APPLICATION NO.	FILING DATE	FIRST NAMED INVENTOR	ATTORNEY DOCKET NO.	CONFIRMATION NO.	
10/670,787	09/26/2003	Seung Jun Han	8733.597.01	4358	
30827 75	90 12/28/2005		EXAM	EXAMINER	
MCKENNA LONG & ALDRIDGE LLP 1900 K STREET, NW			HAN, JASON		
WASHINGTON			ART UNIT	PAPER NUMBER	
			2875		
			DATE MAILED: 12/28/2005	DATE MAILED: 12/28/2005

\$			
	Application No.	Applicant(s)				
	10/670,787	HAN ET AL.				
Office Action Summary	Examiner	Art Unit				
	Jason M. Han	2875				
The MAILING DATE of this communication app Period for Reply	The MAILING DATE of this communication appears on the cover sheet with the correspondence address Period for Reply					
A SHORTENED STATUTORY PERIOD FOR REPLY WHICHEVER IS LONGER, FROM THE MAILING DA - Extensions of time may be available under the provisions of 37 CFR 1.13 after SIX (6) MONTHS from the mailing date of this communication. - If NO period for reply is specified above, the maximum statutory period w - Failure to reply within the set or extended period for reply will, by statute, Any reply received by the Office later than three months after the mailing earned patent term adjustment. See 37 CFR 1.704(b).	ATE OF THIS COMMUNICATION 36(a). In no even

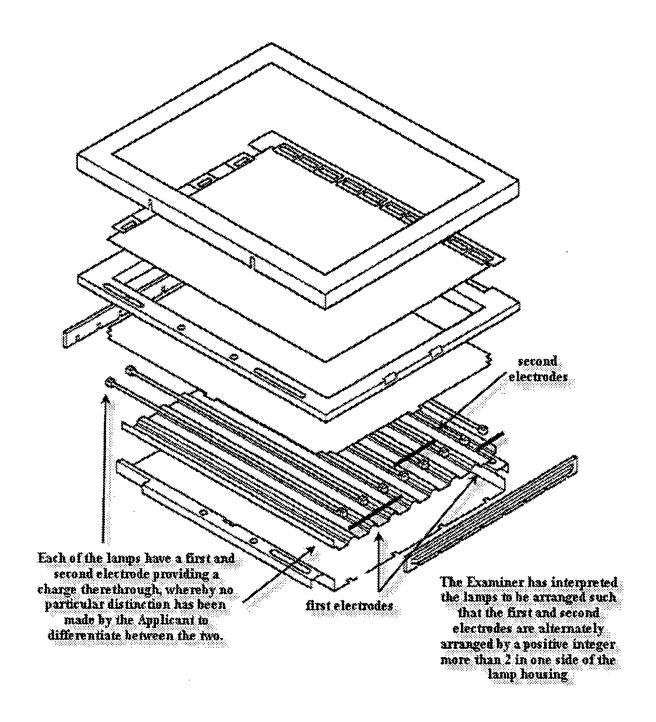
1. Applicant's arguments filed November 14, 2005 have been fully considered but they are not persuasive. The prior art of Itoh (U.S. Publication2002/0030993) remains commensurate to the scope of the claims as stated by the Applicant and broadly interpreted by the Examiner [MPEP 2111]. Below is a recapitulation and elucidation of the Examiner's interpretation and how each of the structural limitations has been satisfied, which the Applicant disputes. It should be noted that the claim language at present is insufficient in structure to render a definite invention over the prior art of record, whereby no distinction has been made between the first and second electrodes (e.g., a high pressure electrode and lower pressure electrode as supported by the specification).

Itoh clearly discloses a backlight unit including:

- A lamp housing [Figure 1: (4)]; and
- A plurality of lamps [Figure 1: (1)] respectively having a first electrode and a second electrode (inherent as shown in the drawing below) and arranged in the lamp housing so that the first and the second electrodes are alternately disposed in one side of the lamp housing (structurally insufficient to read over a broad interpretation by the Examiner as shown in the drawing below).
